## Proposal for the 01 series of amendments of UN Regulation No. 158 (Reversing motion)

### Submitted by the expert from the Informal Working Group on Awareness of Vulnerable Road Users Proximity

**“Arrangement of approval mark of a device for indirect vision**

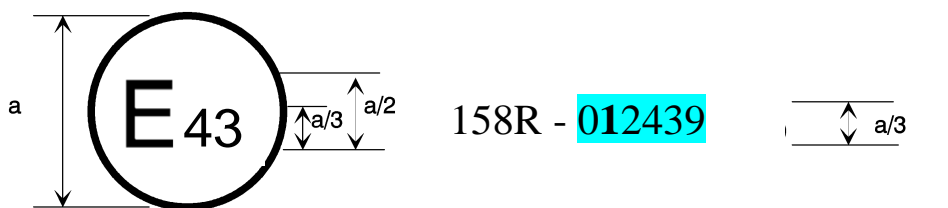
Annex 5. amend to read:

The above approval mark affixed to a device for indirect vision indicates that the device is a main Close-proximity rear-view device, which has been approved in Japan (E 43) pursuant to UN Regulation No. 158 and under approval number 0012439. The first two digits of the approval number indicate that the approval was granted in accordance with the requirements of UN Regulation No. 158 in its original form as amended by the 01 series of amendments.
